SCHEMATIC PLAN

FRA-71-14.36

Ohio DOT Workspace
70171 West Interchange 6R
www.mscconsultants.com

SECTION A-A
SCALE: 1"=10'

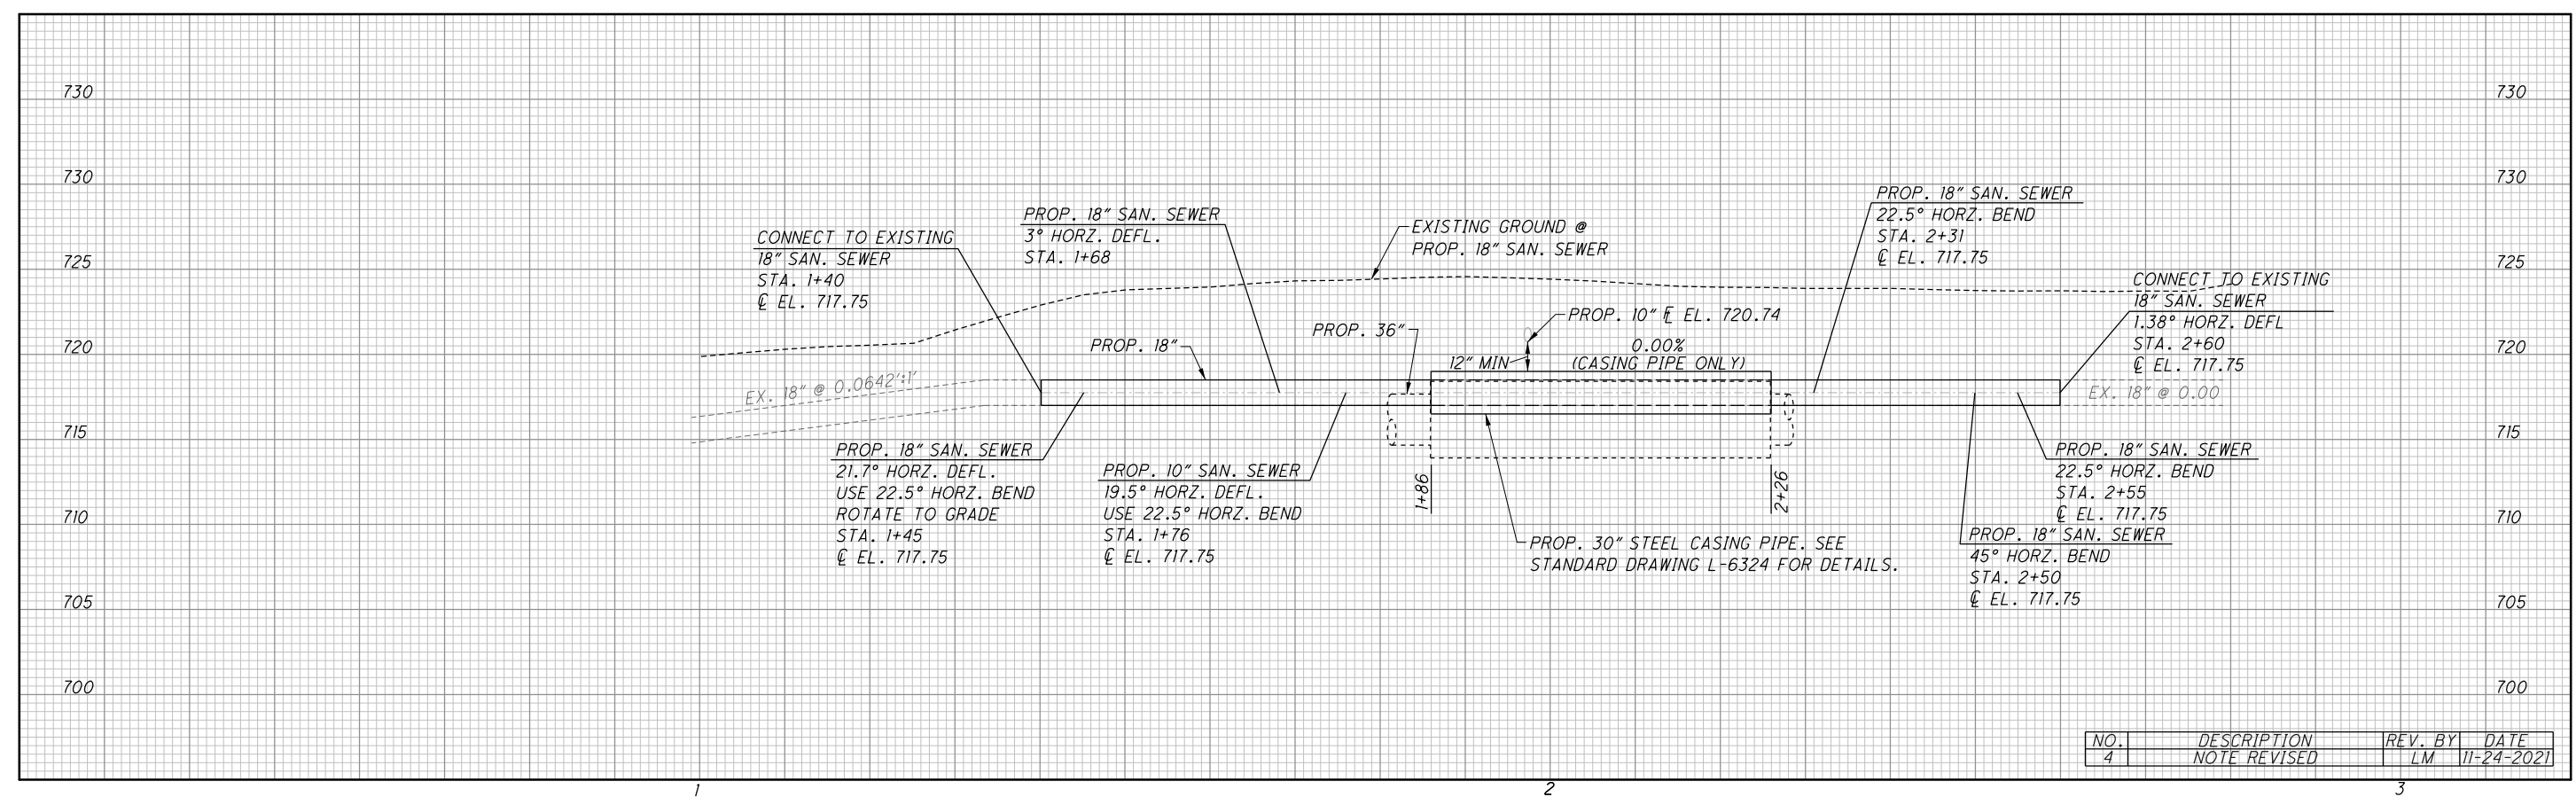
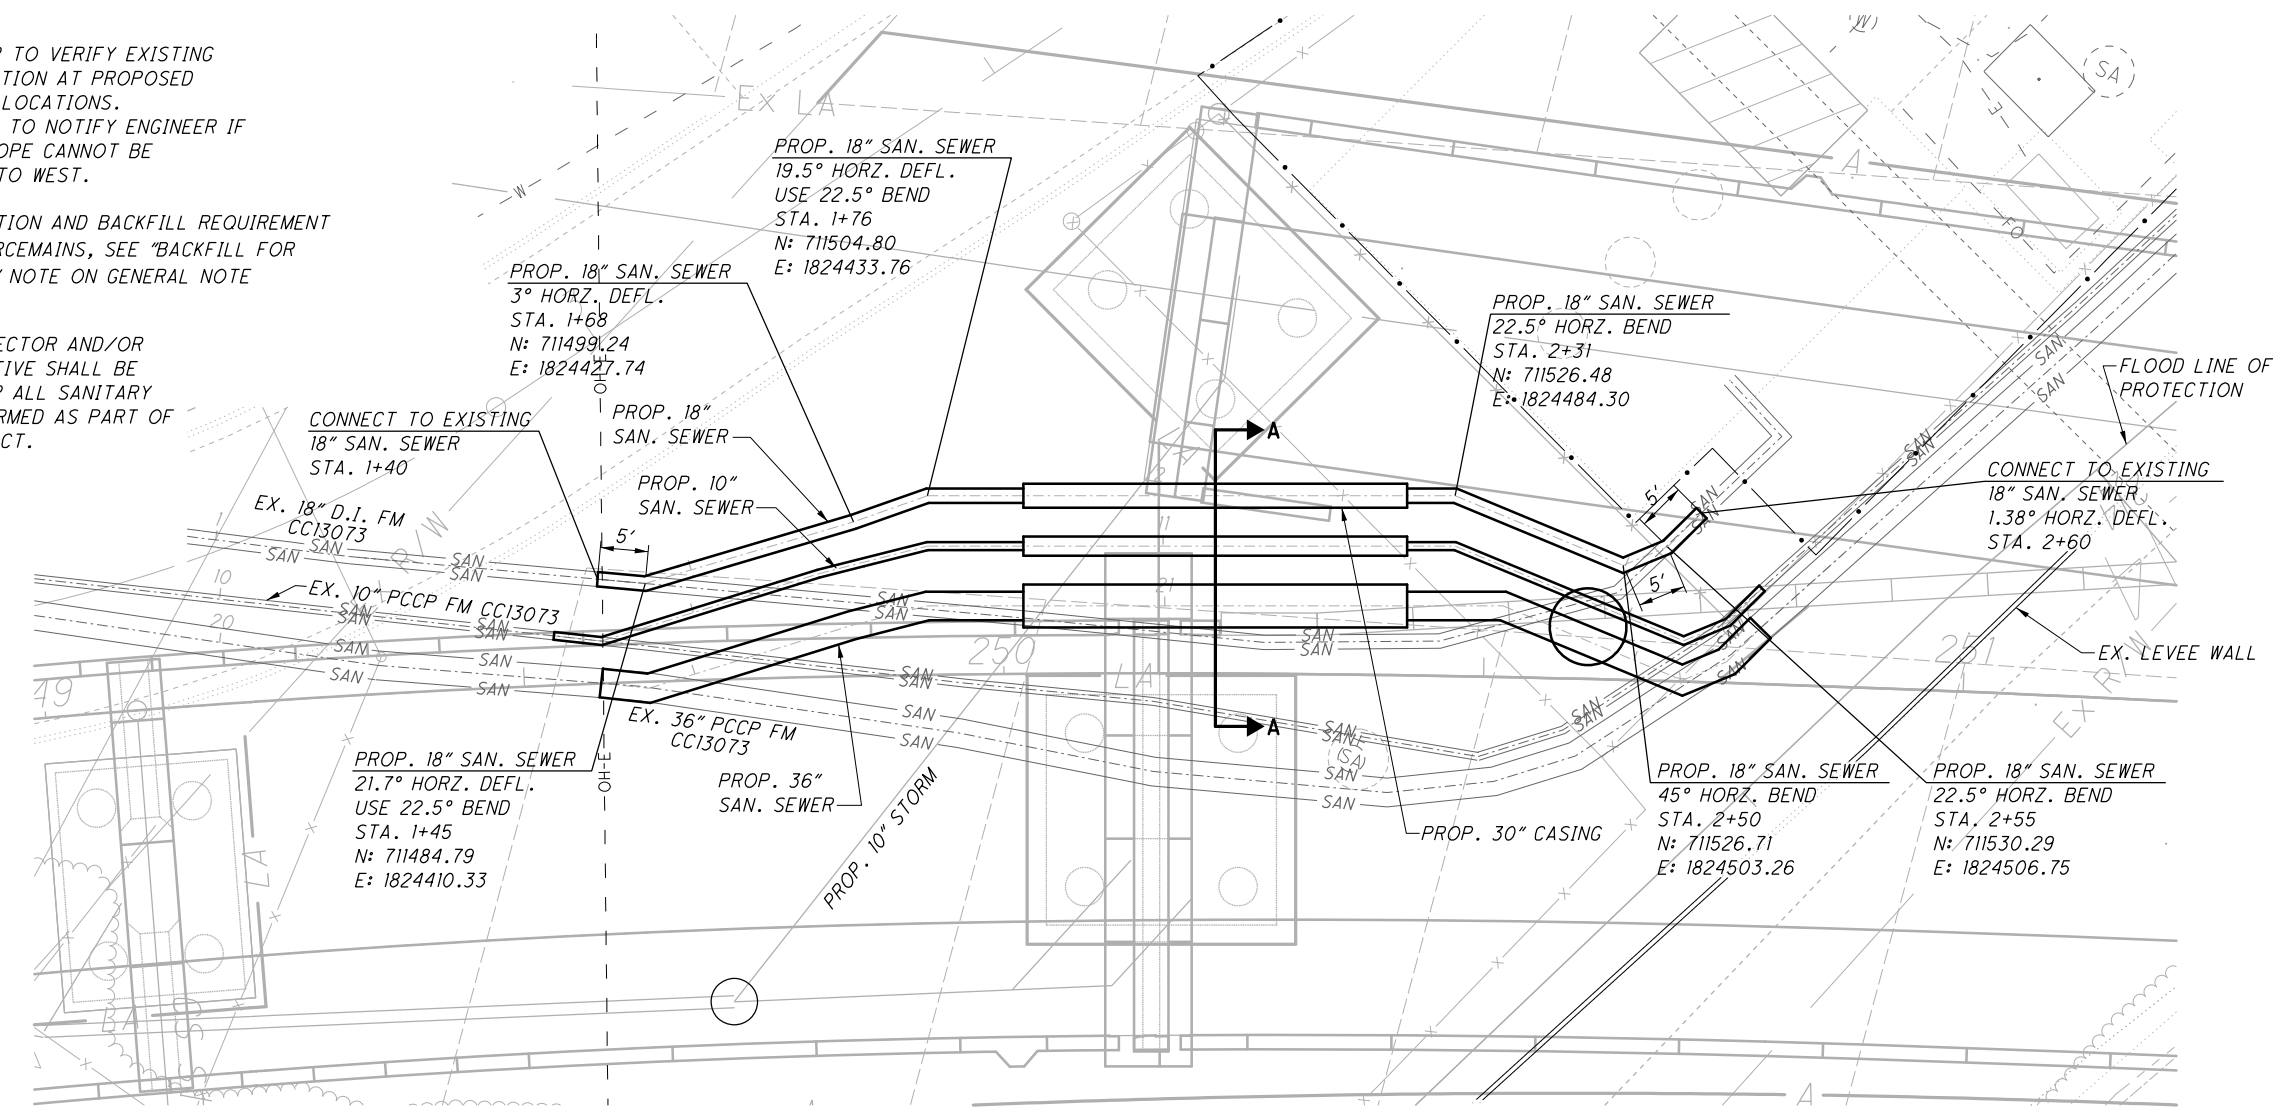
NO.	DESCRIPTION	REV. BY	DATE
4	NOTE REVISED	LM	11-24-2021

- FOR EXCAVATION AND BACKFILL REQUIREMENT FOR THE FORCEMAINS, SEE "BACKFILL FOR FORCEMAINS" NOTE ON GENERAL NOTE SHEET 46.
- A CITY INSPECTOR AND/OR REPRESENTATIVE SHALL BE PRESENT FOR ALL SANITARY WORK PERFORMED AS PART OF THIS CONTRACT.

SECTION A-A
SCALE: 1"=10'

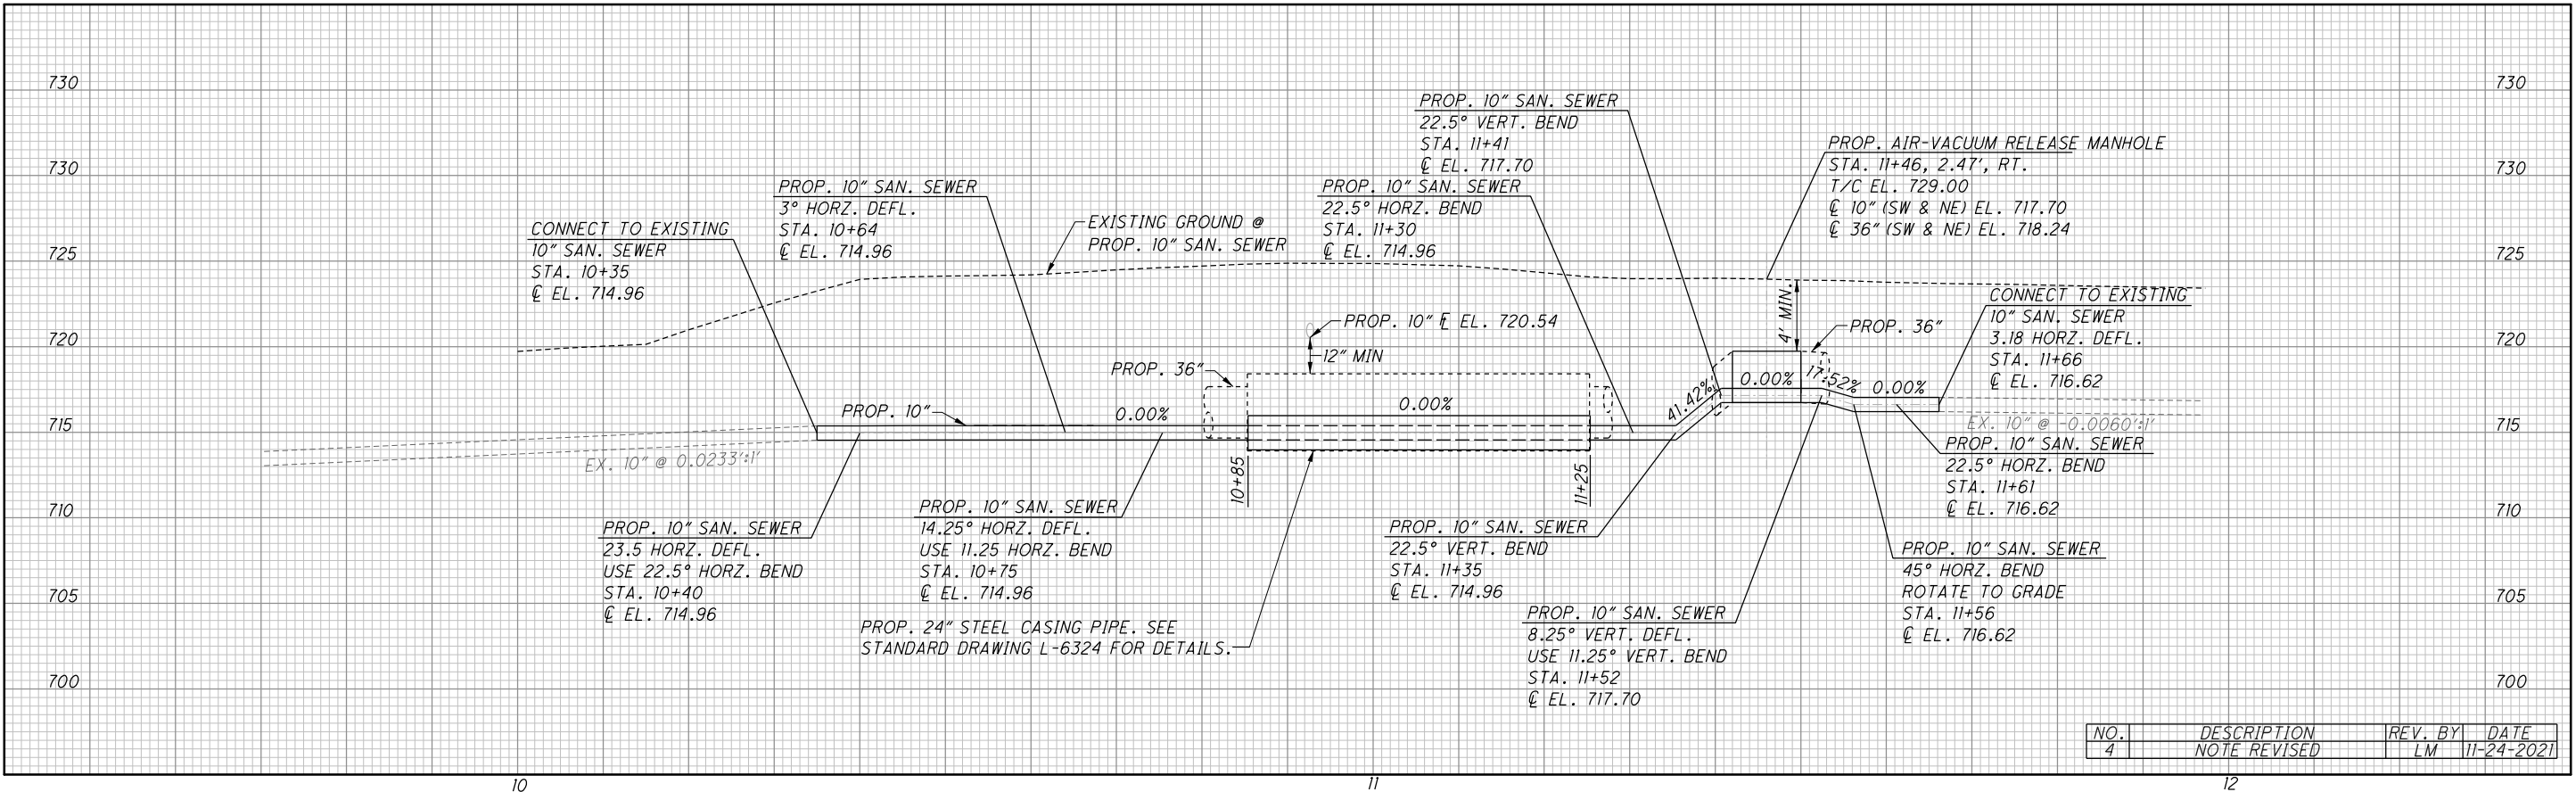
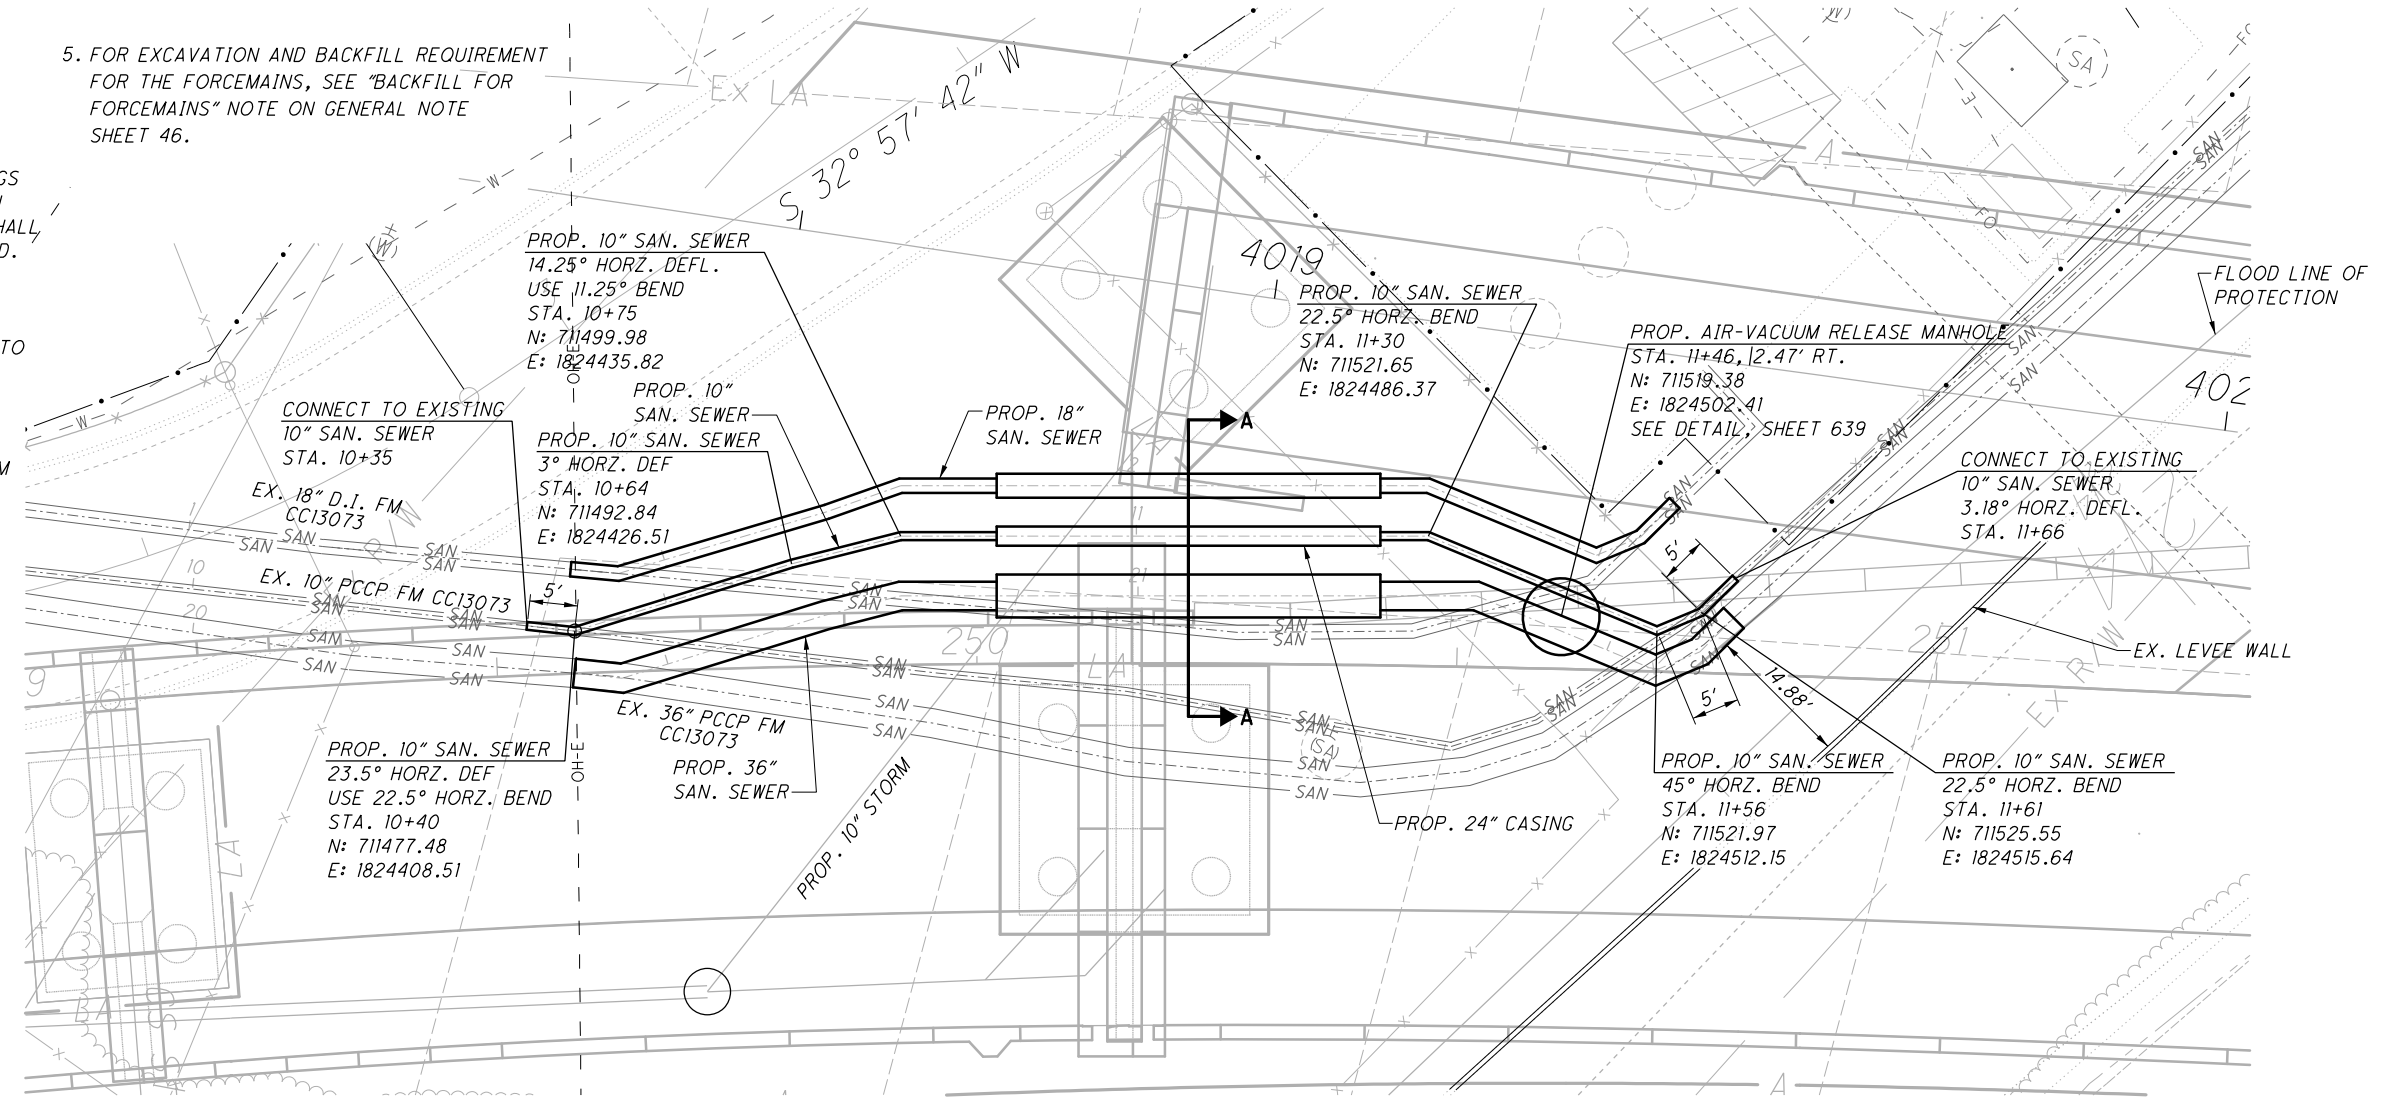
NO.	DESCRIPTION	REV. BY	DATE
4	NOTE REVISED	LM	11-24-2021

5. FOR EXCAVATION AND BACKFILL REQUIREMENT FOR THE FORCEMAINS, SEE "BACKFILL FOR FORCEMAINS" NOTE ON GENERAL NOTE SHEET 46.
